7 September, 1998

Circular No. 12/98
Available Car Area

Sketch for Circular No. 12/98

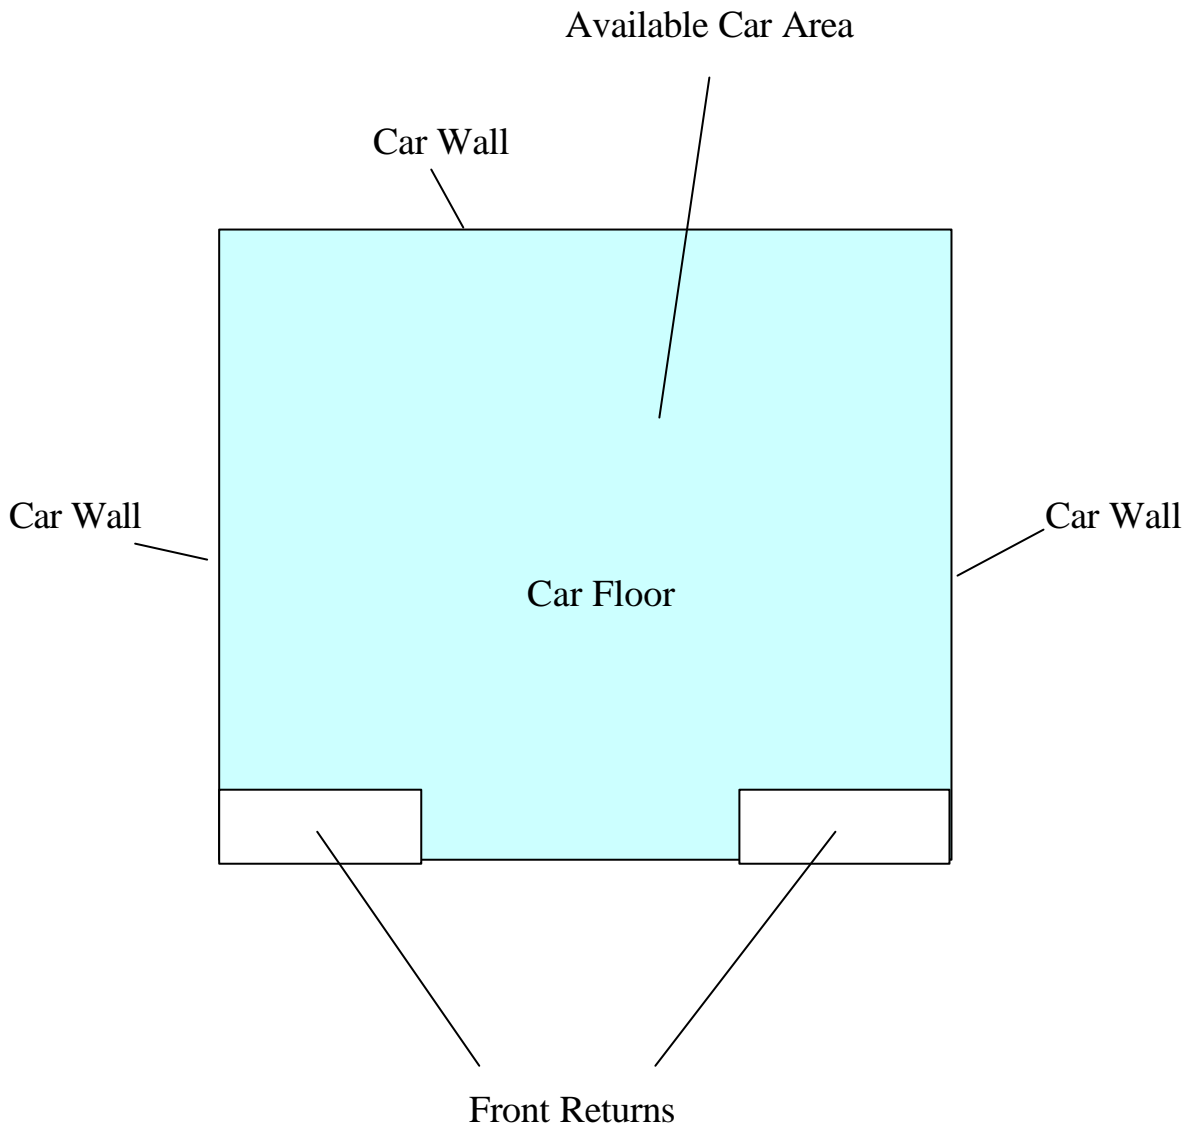
In a recent liaison meeting with the lift contractors associations, we were requested to clarify on the calculation of available car area.

As stated in Clause 4.2.1 of the Code of Practice on the Design and Construction of Lifts and Escalators, recesses and extensions shall be taken into account in the calculation of maximum available car area. As such, all the car floor area (as shown in the sketch) including the area between the 'front returns' must be taken into account in the calculation of maximum available car area.
